Planning Assessment Officer Report

PA2604266 –724-728

Whitehorse Road, Mitcham

Planning Assessment Officer Report
Development Assessment

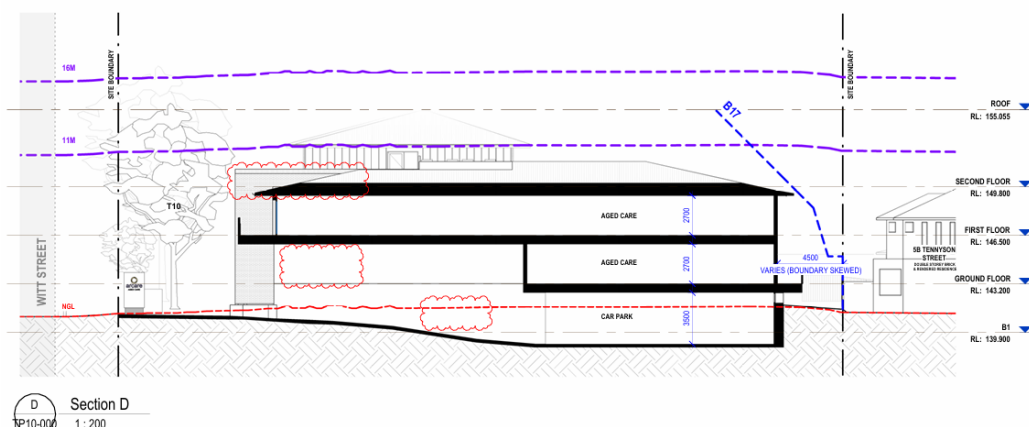
67. Clause 53.17 (Residential Aged Care Facility) prescribes a maximum height of 16 metres for an RAC building in the General Residential Zone, which prevails over any other otherwise applicable building height requirement in the planning scheme. The building is proposed to be constructed to a maximum height of 12.885m and is therefore compliant with the height requirement of Clause 53.17.

68. Whilst the immediate surrounding development generally consists of one and two storey residential development, the proposed 3 storey form is compliant with the underlying storey limit prescribed by the GRZ2 and the recession and design details of the upper level, will assist ensuring the building mass is not dominant and integrates with the streetscape.

Above: Section D, eastern section diagram.

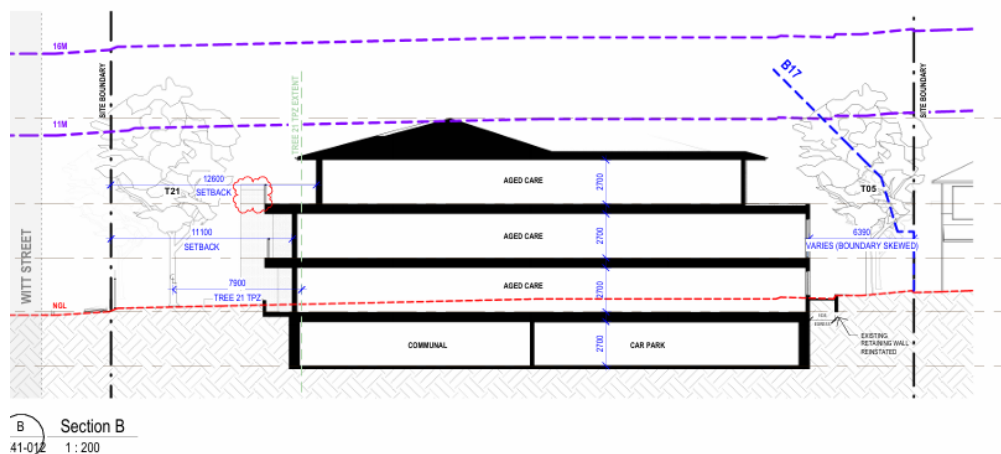
73. The proposed development is designed to fully comply with the side and rear setback development requirements of Clause 53.17, and the upper level of the development has been purposely sited and designed to be recessed from the levels below. This will assist in limiting visual bulk impacts and is an appropriate response to the neighbourhood character. Compliance with the Clause 53.17 setback requirements is demonstrated in the following eastern sections:

74. The proposed front, side and rear setback requirements are also acceptable having regard to the SLO9, as sufficient space is provided between the built form and adjoining boundary to retain a sufficient number of mature trees and to facilitate the planting of new trees and vegetation. This will ensure the site continues to positively contribute to the leafy garden and bushy character of the area.
